Staff Report to the
Municipal Planning Board
April 19, 2022

MPL2022-10013

BAINBRIDGE UNIVERSAL APARTMENTS

Applicant's Request: Master Plan request for a 367-unit apartment complex with structure parking garage.

PROPOSED BUILDINGS ELEVATIONS

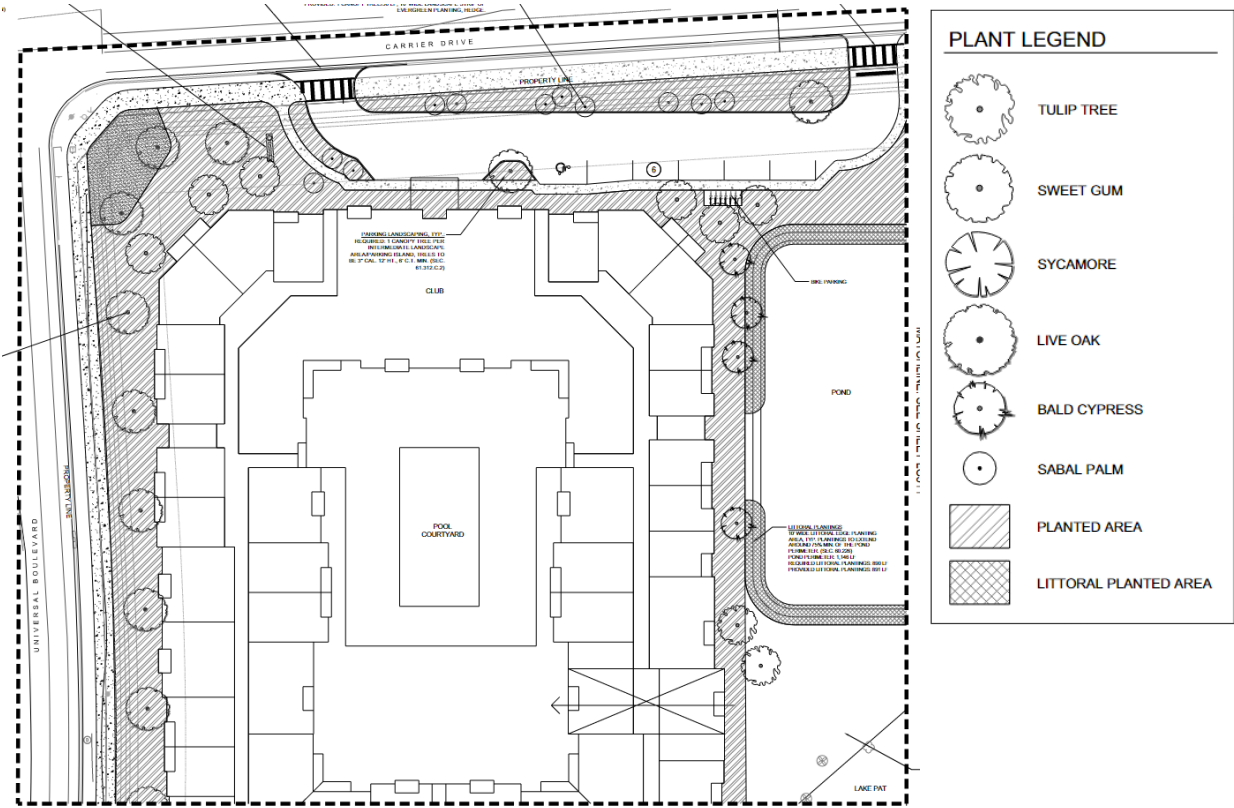
Staff is requesting that additional ornamentation and architectural treatments be added to the apartment buildings, as well as sidewalks that will tie into the existing external pedestrian sidewalks on Universal Blvd. Stormwater will flow into a new stormwater pond in the northeast portion of the property.

3. All facades must be finished with the same materials and architectural details. Side and rear building facades that are visible from a street must contain architectural detail comparable in appearance and complexity to the front(s) of the building(s).

6. Additional height and articulation at the corners of the building must be added to increase the skyline variations and to better define the mass and extent of the building.

LANDSCAPE PLAN

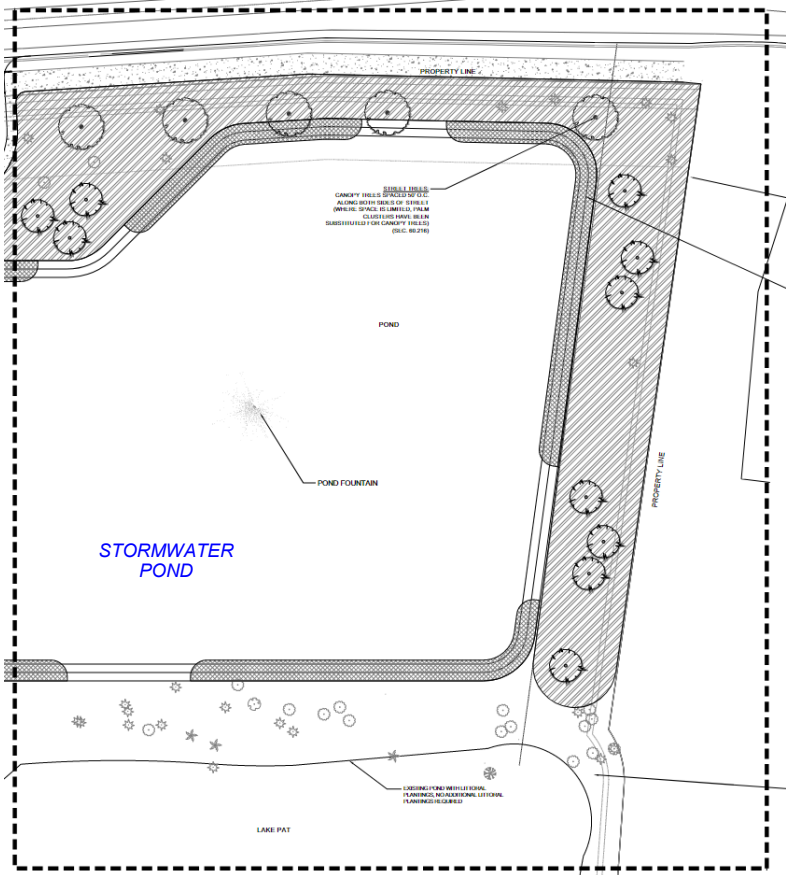
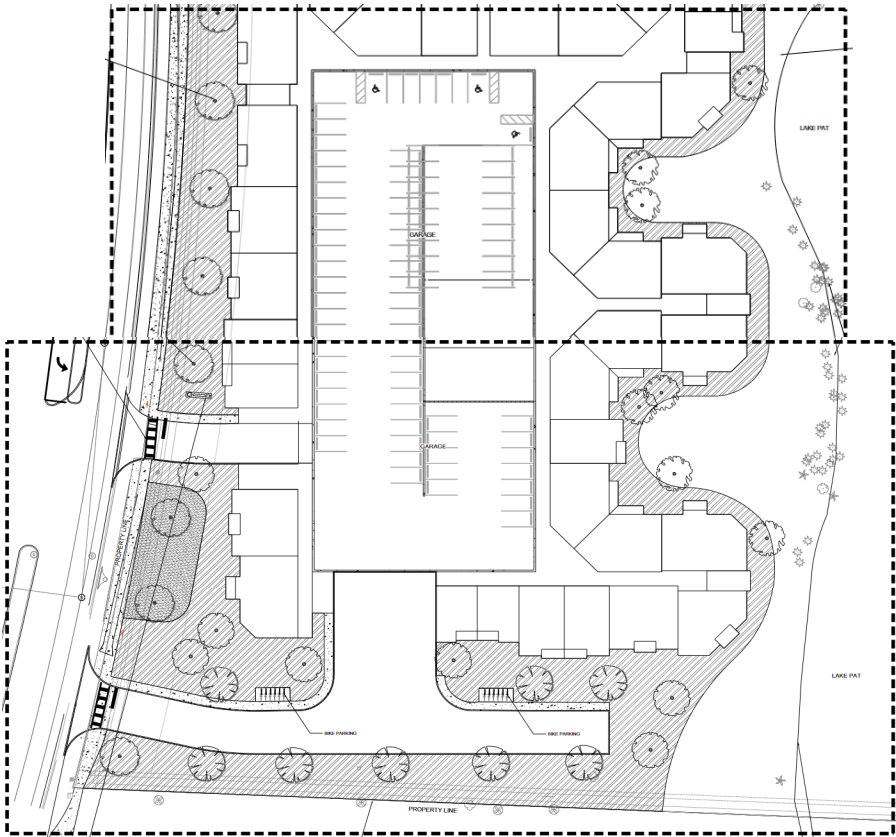
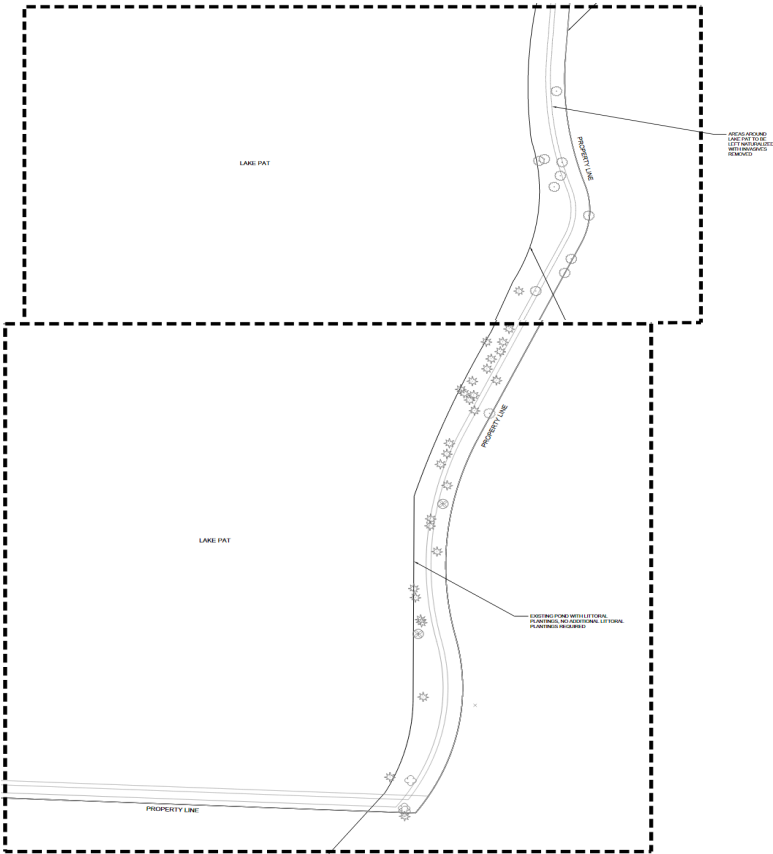
2. Landscape Plan legend must include plant schedule, with type and quantity of shrubs, understory trees, and canopy trees.
3. The landscape plan must meet all standards found in Sec. 62.496. - North International Drive Special Plan, in addition to chapters 60 and 61.

4. The MRLS must be increased by 10% within the Special Plan area in order to promote and execute a tropical landscape, via a mixture of different sized plants, varying shades of green, and varying leaf sizes and shapes are encouraged to create textured layers and make the area more visually interesting.

5. Street trees must be provided on the park strip between the curb and the sidewalk, along the length of Universal Blvd and Carrier Drive, as required to meet the street tree requirements of Chapter 60.
